Access Compliance Report

Public Rights-of-Way

(Curb Ramps)

Intersection ID: 44929	Main Street: TWIN_BROOK_DR	Cross Street: NATHAN_DR	Location: W
ADA ID: 59DD8CA9642C	Ramp Type: Perp	Initial Pass/Fail: Fail	Overall Compliance: No
		Severity Score: 8.75

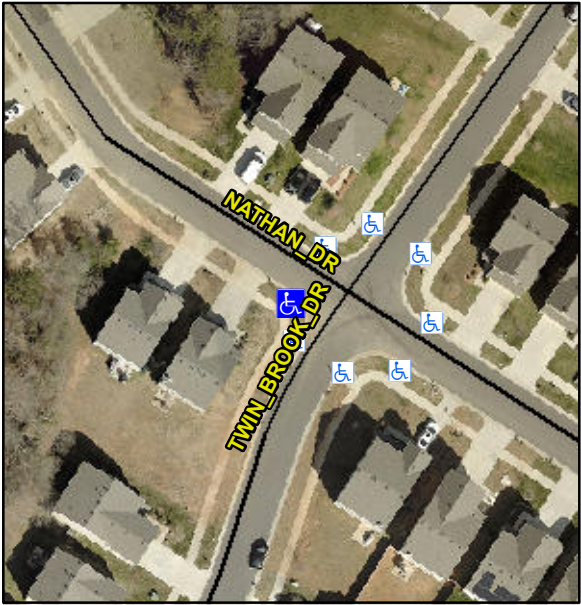
Codes/Mitigation Info/Possible Solution			Field Measurements/Component Compliance		
	Possible Solutions:		Compliance	Description	Data
	Remove & Replace Entire Ramp.		Yes	Ramp Length (in)	94.5
			Yes	Ramp Width (in)	44.0
			N/A	Flare Type LT	N/A
			N/A	Flare Slope LT (%)	N/A
			N/A	Flare Traversable LT?	N/A
			N/A	Landing Length (in)	N/A
			N/A	Landing Width (in)	N/A
			N/A	Landing Slope (%)	N/A
			N/A	Landing X Slope (%)	N/A
<p>Surveyor Notes:</p> <p>N/A</p> <p>PROW/ADA:</p> <p>Not Found, R304.5.1</p>			N/A	Flare Type RT	N/A
			N/A	Flare Slope RT (%)	N/A
			N/A	Flare Traversable RT?	N/A
			N/A	DWS Provided?	N/A
			N/A	DWS Contrast?	N/A
			N/A	DWS Length (in)	N/A
			N/A	DWS Full Width?	N/A
			N/A	DWS Offset (in)	N/A
			N/A	Gutter Ponding?	N/A
			N/A	Gutter Lip Ht (in)	N/A
			No	Painted X Walk1?	N/A
				X Walk 1 Direction	To NW
			N/A	X Walk 1 Width (in)	N/A
				X Walk 1 Slope (%)	1.2
				X Walk 1 X Slope (%)	0.1
			N/A	Ramp inside XWalk1?	N/A

N/A	Ramp inside XWalk2?	N/A
			N/A	Road Slope (%)	N/A
			N/A	Road X Slope (%)	N/A
			N/A	Any Obstructions?	N/A
Total Cost:		\$ 1850.00		Obstruction Type	
			N/A	Storm Grate/Utility Hazard?	N/A
				Storm Grate/Utility Type	
			N/A		N/A
			Yes	Surface Condition? (G/P)	Good
